Fire Safety Works

Project:
Presbytery: Fabric upgrade, fire
alarm & emergency lighting.

Description:
Scope of Works Grd & Basement

Job No: 4118 Status Code: S3 Drawing No: FSW/01 Rev: B

Basement Plan (1 to 100 @ A3)

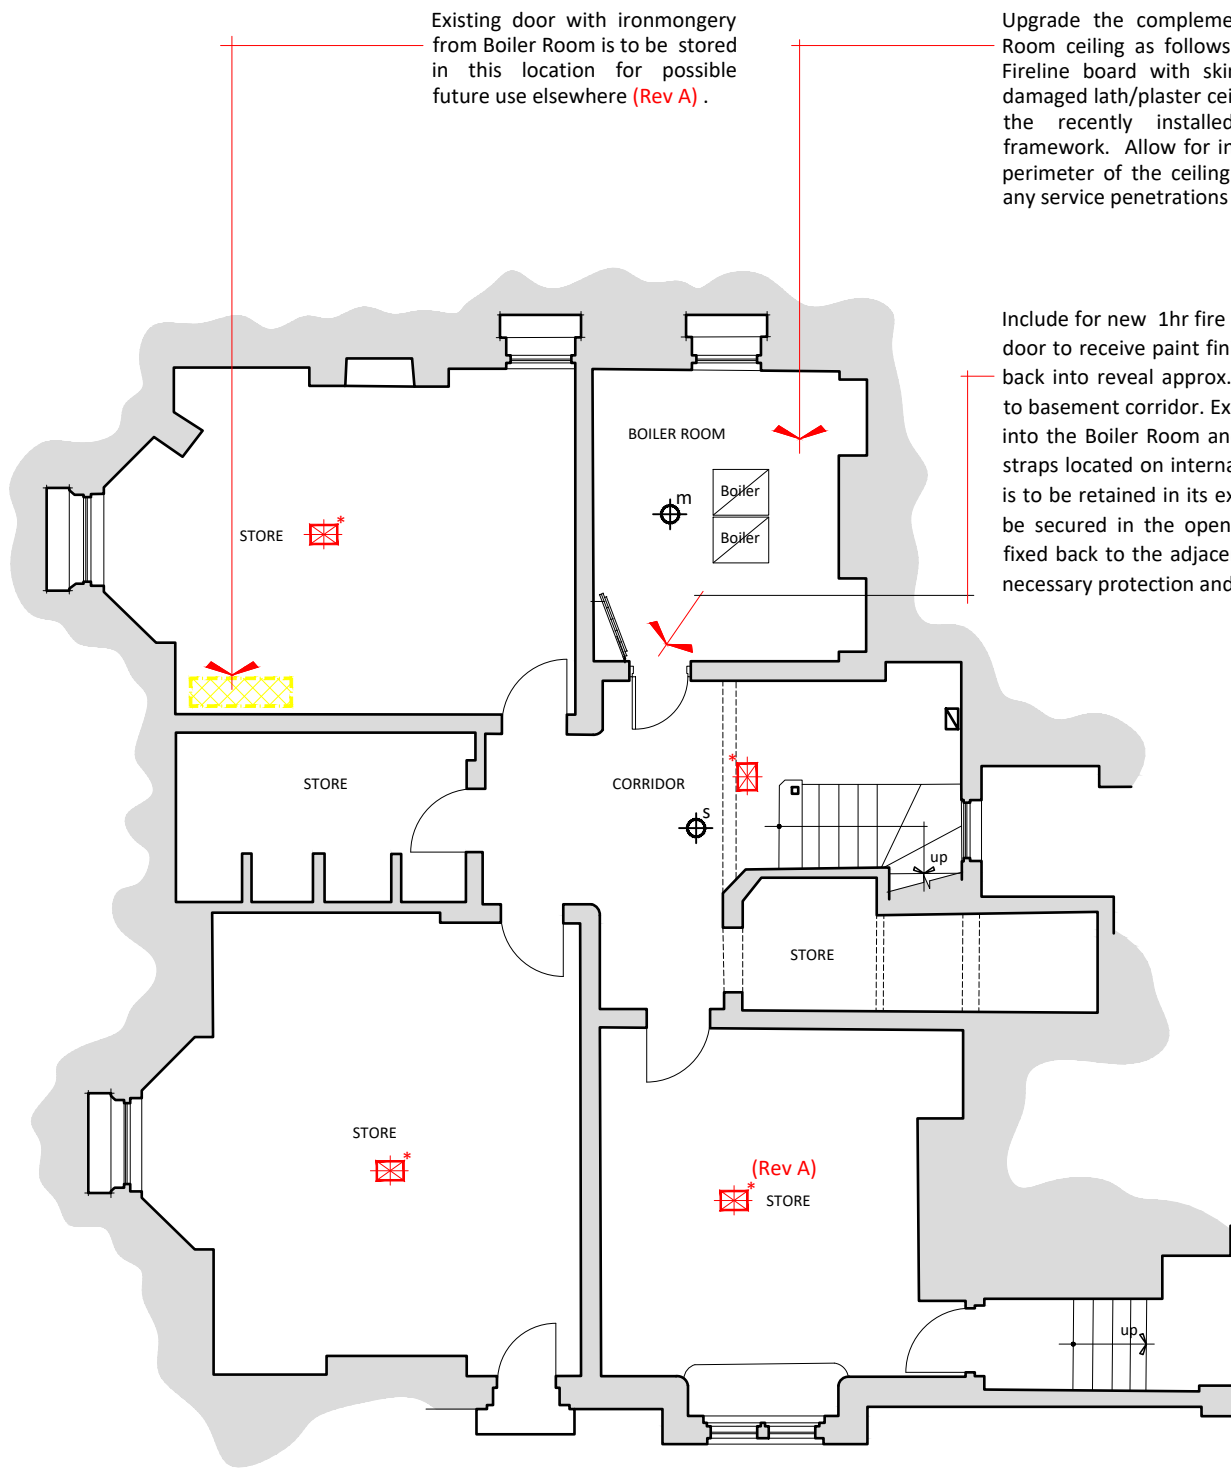
Existing door with ironmongery from Boiler Room is to be stored in this location for possible future use elsewhere (Rev A) .

Upgrade the complementation of the basement Boiler Room ceiling as follows. Supply and fix 12.5mm Gyproc Fireline board with skim finish fixed over the existing damaged lath/plaster ceiling. Allow for framing out around the recently installed heating pipework/supporting framework. Allow for intumescent sealant (Rev A) to the perimeter of the ceiling & wall junction and to fire stop any service penetrations in the new ceiling.

Include for new 1hr fire resistant solid core plywood faced door to receive paint finish. New door is to be located set back into reveal approx. 50mm from face of outside wall to basement corridor. Existing historic boarded door opens into the Boiler Room and is hinged on gudgeon pins with straps located on internal face of the separating wall. This is to be retained in its existing position/condition but is to be secured in the open position with a chain and hook fixed back to the adjacent brick wall. (Rev B) Allow for all necessary protection and full clean on completion.

Upgrade fire resistance of the existing panelled basement access door consisting of the following. Temporarily remove the door & ironmongery to allow for adaption. Allow for refixing on completion, including intumescent pads to the hinges and lock. Fix Supalux fire resistant boarding to the basement side of the existing door New boarding to be painted out and to be fixed using brass cups and screws with fixed with intumescent sealant to the board joints and perimeter of the boards. Rout out the existing door frame and fix new intumescent smoke/heat brush seal. Allow for decoration of the frame and door. Allow for all necessary protection and full clean on completion.

Ground Floor Plan (1 to 100 @ A3)

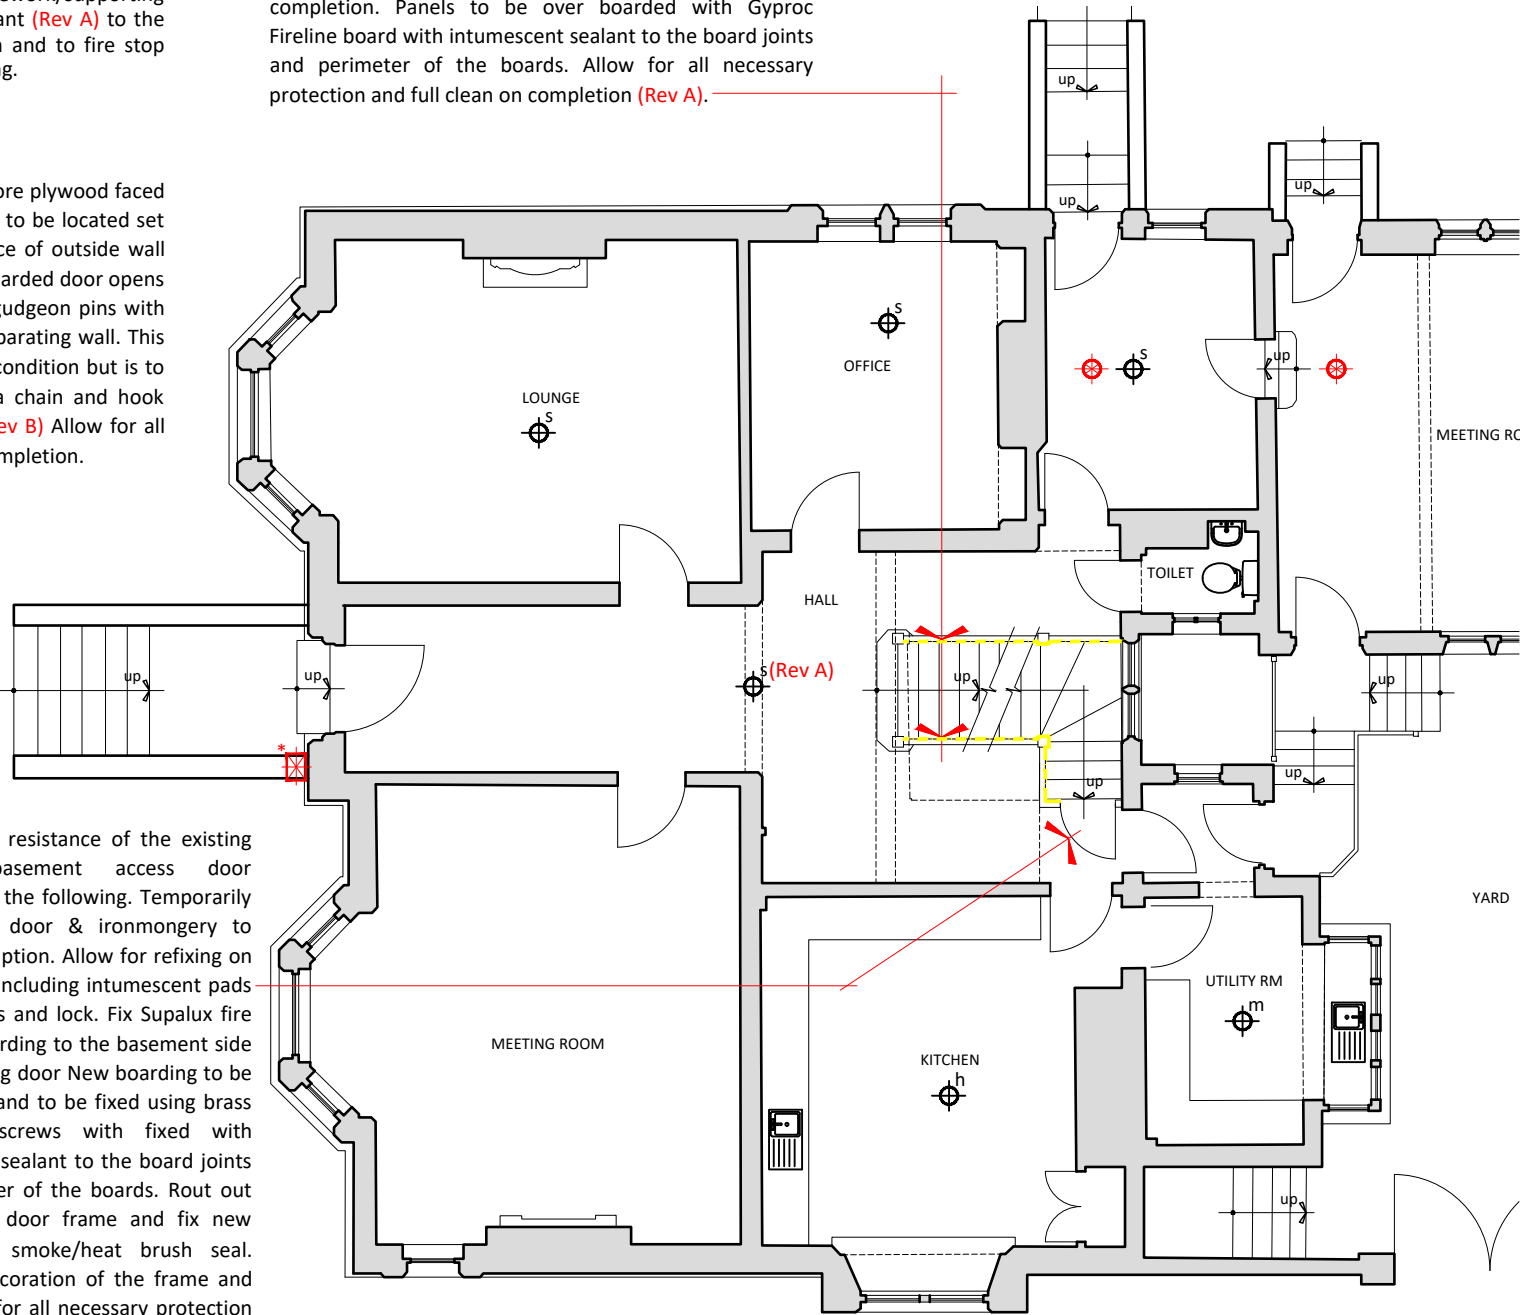
The upgrade of the fire separation to the timber partition at either side of the top section of the Basement/Escape Stair to include for temporary removal of the existing surface mounted electrical accessories/conduits. Refix on completion. Panels to be over boarded with Gyproc Fireline board with intumescent sealant to the board joints and perimeter of the boards. Allow for all necessary protection and full clean on completion (Rev A).
